**विषय** कुनोली - मुनड़ा - देवलीखाल मोटर मार्ग (प्रस्ताव सं० 10159/2015)

उपरोक्त विषयक मोटर मार्ग में लगाई गयी आपत्तियों का बिन्दुवार निराकरण निम्नवत है।

**विषय :-** जनपद अल्मोड़ा में विधानसभा सल्ट के अन्तर्गत कुलोली मुनड़ा देवीखाल मोटर मार्ग का निर्माण।(16.00 किमी.) (0.405है०) (प्रस्ताव सं. FP/UK/ROAD/10159/2015)।

जीयोरफरेन्स मैप - जनपद अल्मोड़ा में राज्य योजना के अर्न्तगत कुनोली - मुनड़ा - देवीखाल  
मोटर मार्ग निर्माण हेतु चयनित क्षतिपूरक वृक्षारोपण स्थल

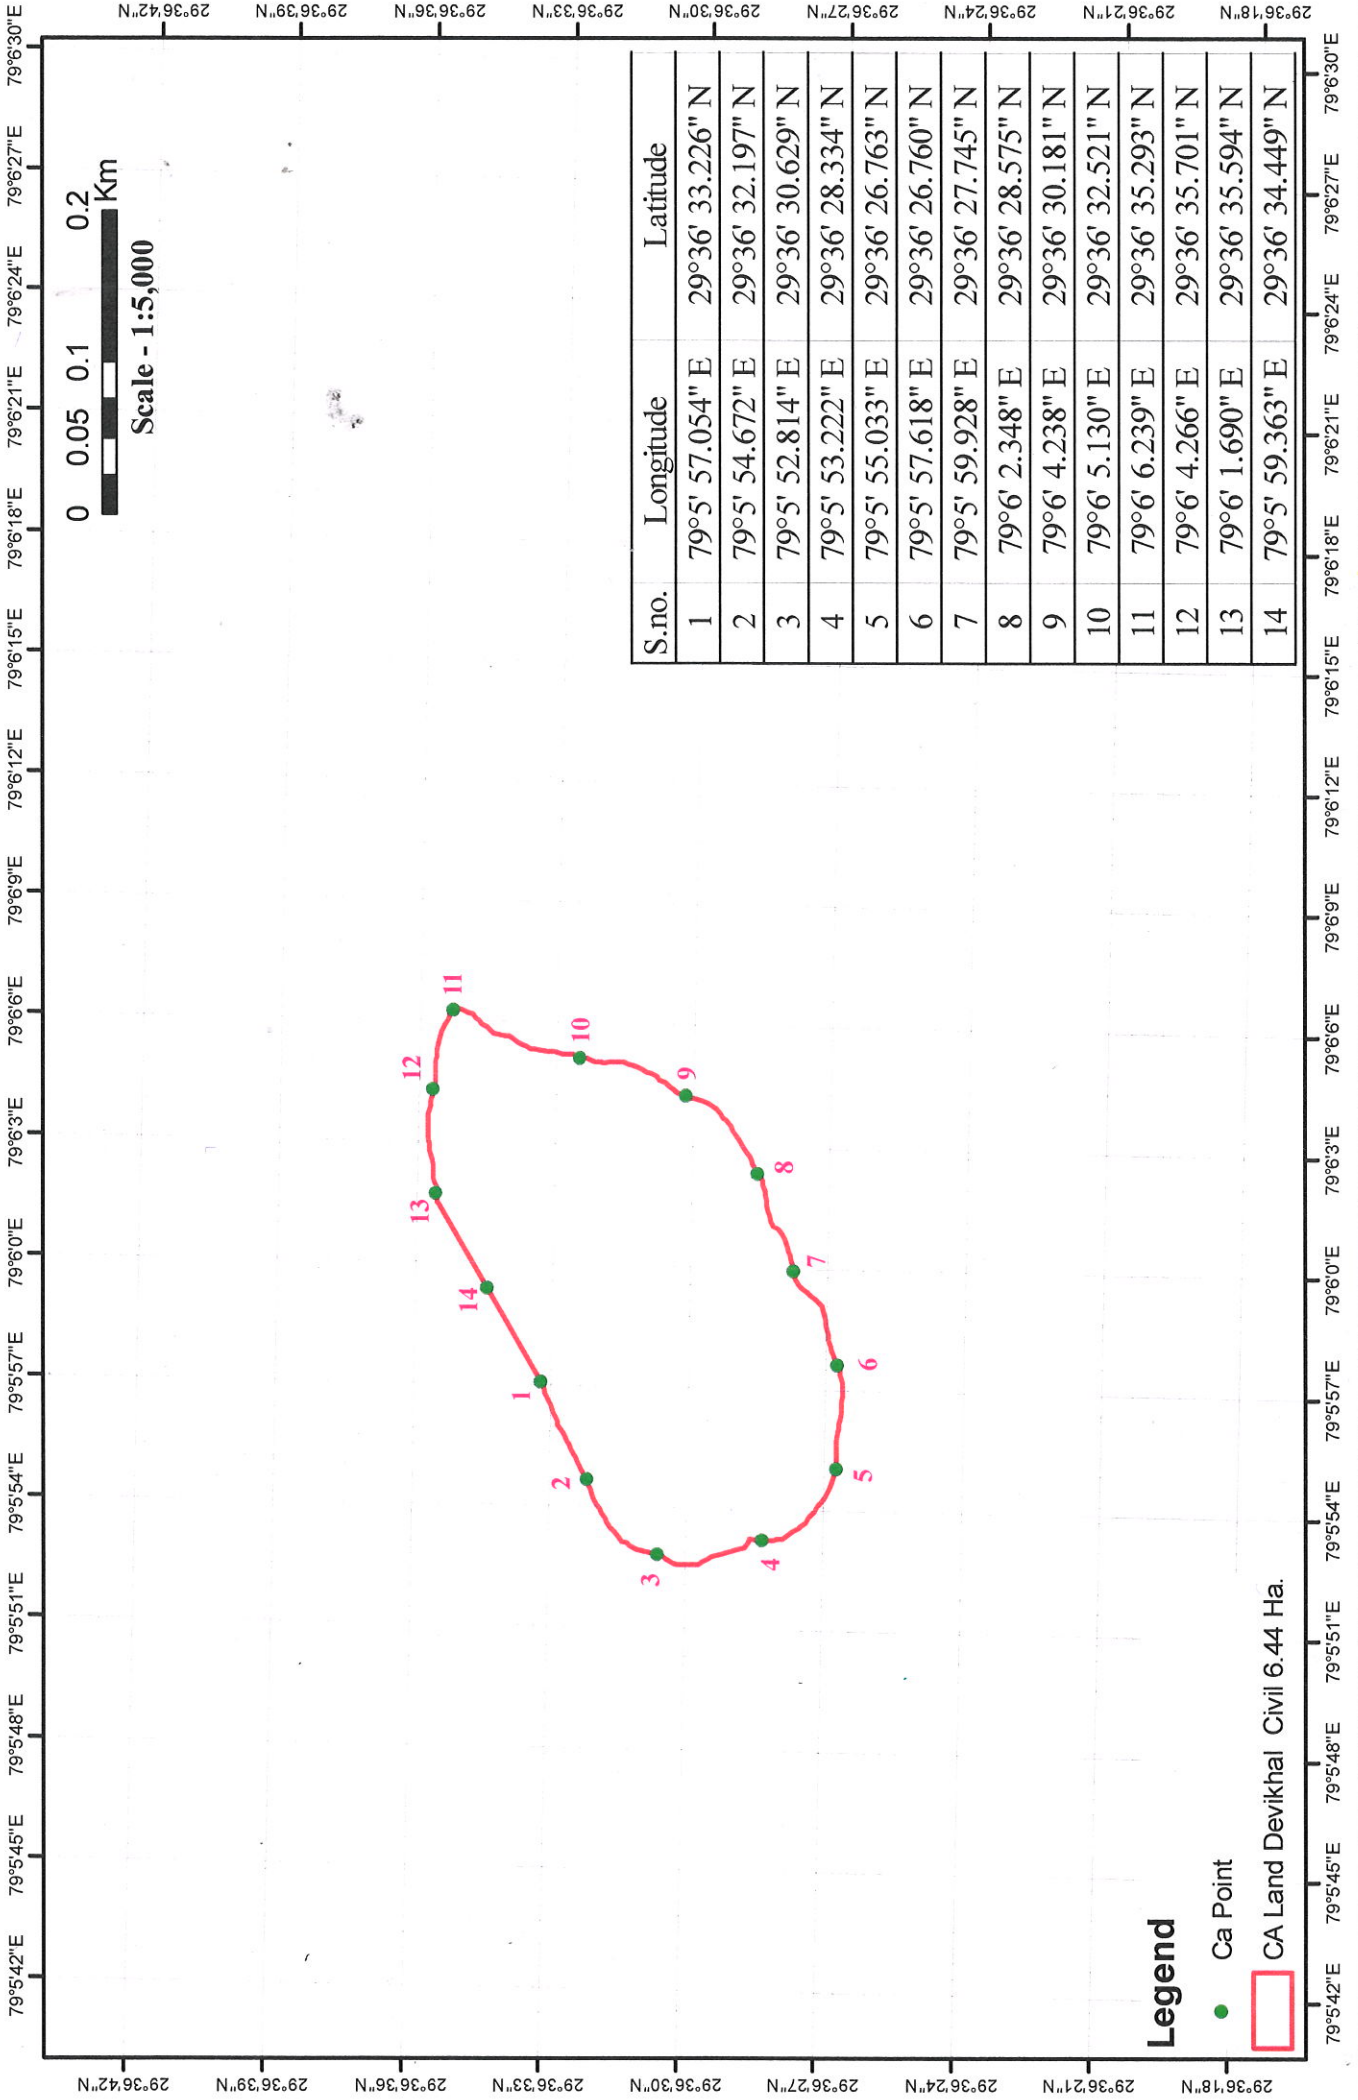
5.	The digital map of area proposed for CA is provided does not serve the purpose. May provide/upload GIS software generated geo referenced digital map of the area proposed for CA providing geo coordinates at all corner points in shape (polygon/closed area) file. The area should be exclusively marked of area proposed for CA i.e. 6.44 ha, not the whole land bank of 8.372 ha. The State Govt may revise the KML file accordingly and upload the revised KML file for the area 6.44 ha in online Part I.	GIS software generated digital map of the area i.e. 6.44 ha attached G.P.S. coordinates of the points marked in digital map attached in excel sheet. Revised Kml file of CA for the area 6.44 ha attached in online Part-I. L-(iv)-(c)

# जीयोरेफेरेंस मैप – जनपद अल्मोड़ा में राज्य योजना के अर्न्तगत कुनोली – मुनड़ा – देवीखाल मोटर मार्ग निर्माण (लम्बाई 15.00 कि०मी०)

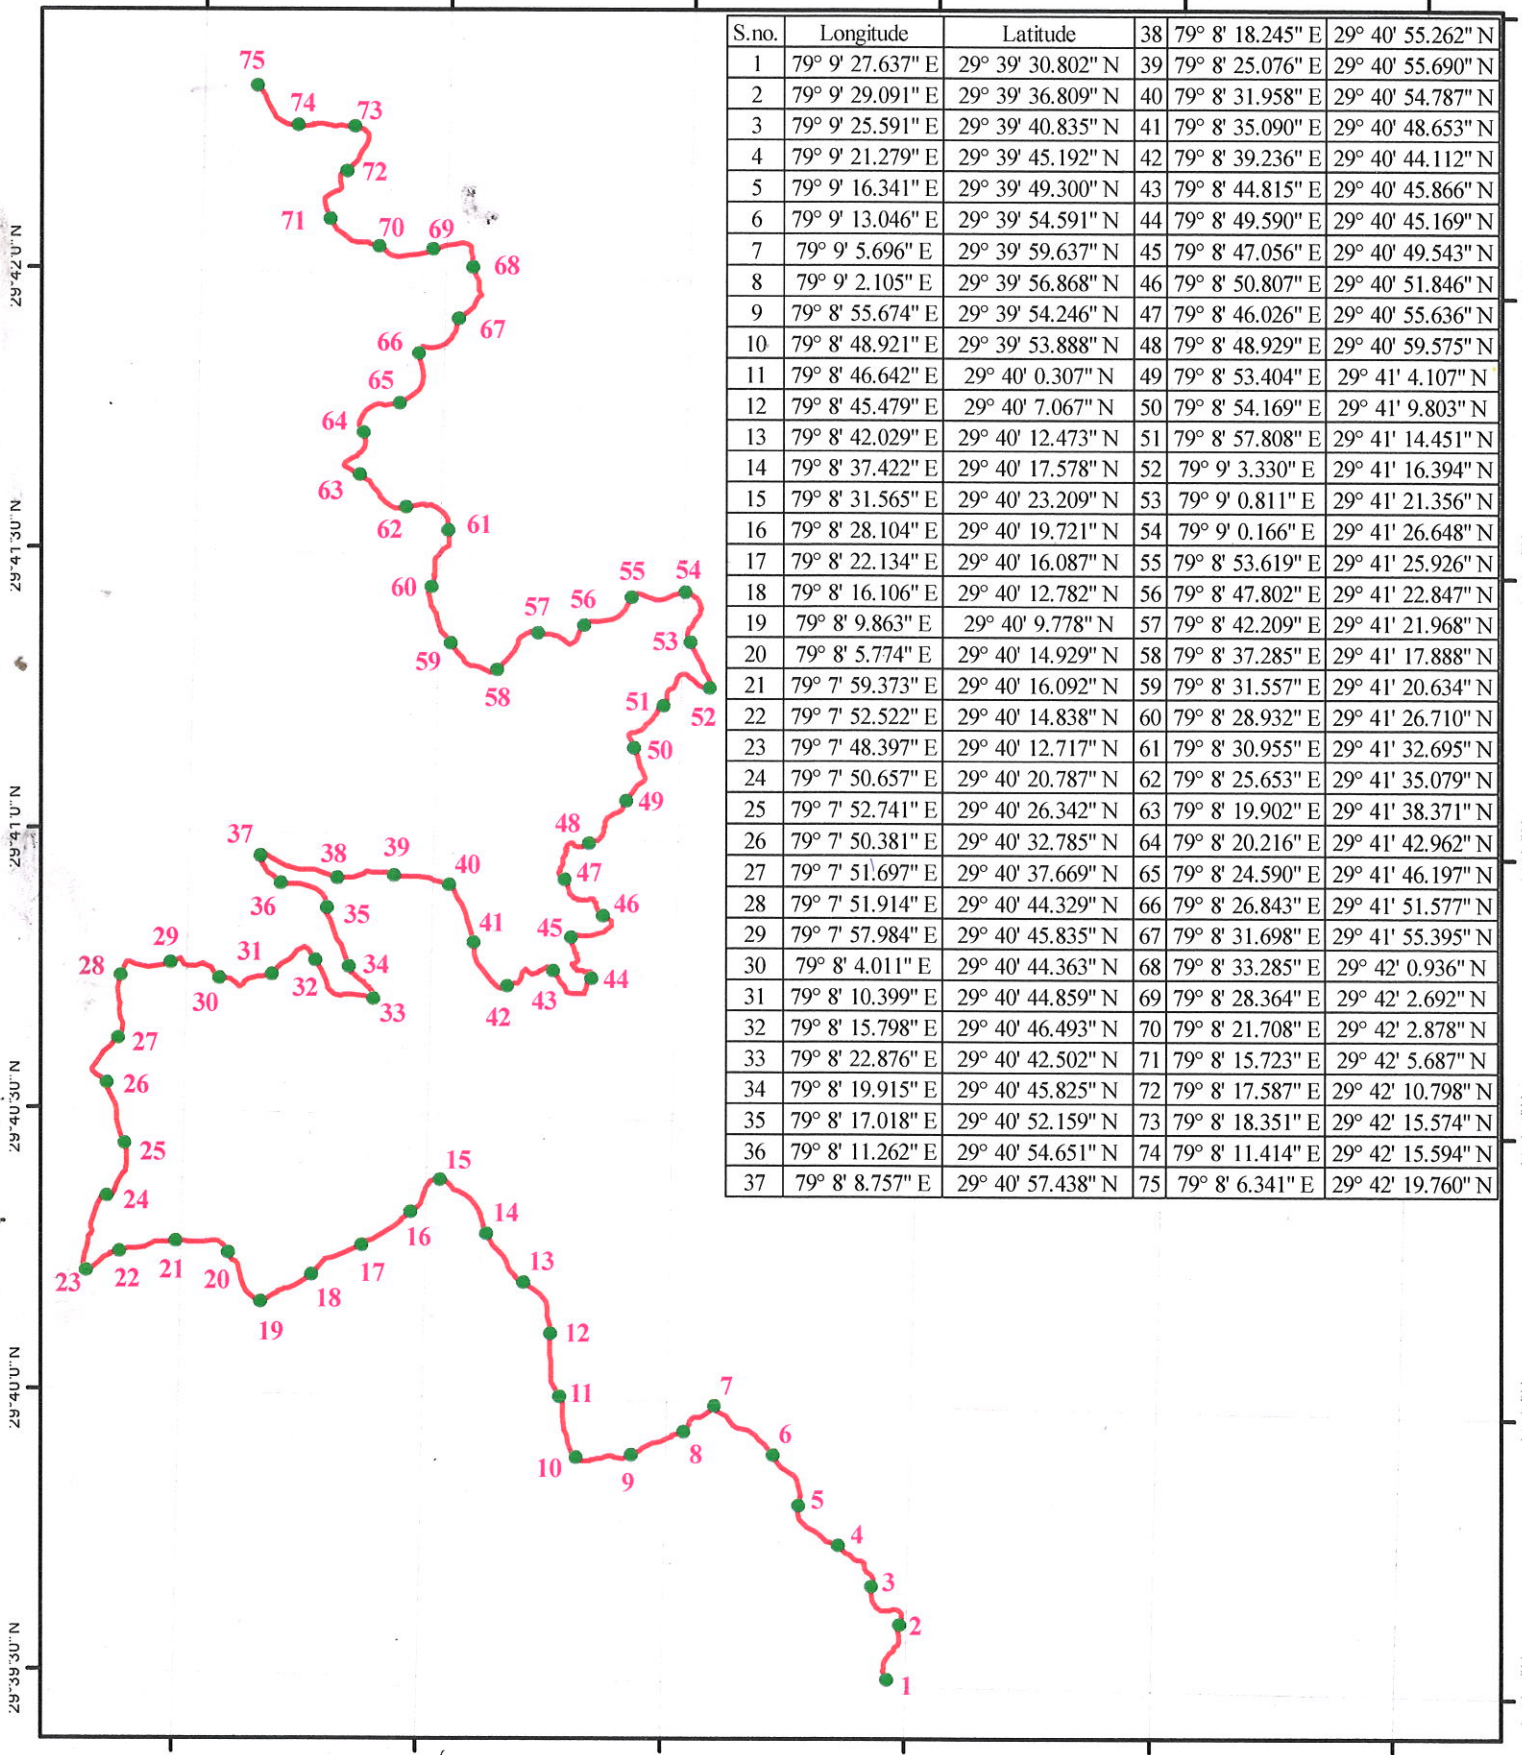
4.	In the geo referenced digital map of the area proposed for diversion, uploaded at C (iv) part I online, geo coordinates are shown at very few points. May provide/upload scanned copy of GIS software generated geo referenced digital map to the exact scale of the proposed road showing geo coordinates at 200 to 300 m interval along the alignment including all the turning points.	GPS coordinate along the road alignment are shown at each and every possible places in geo reference map (Annexure-I). List of G.P.S. coordinates at every 200-300m interval in excel sheet attached for reference. C(iv)
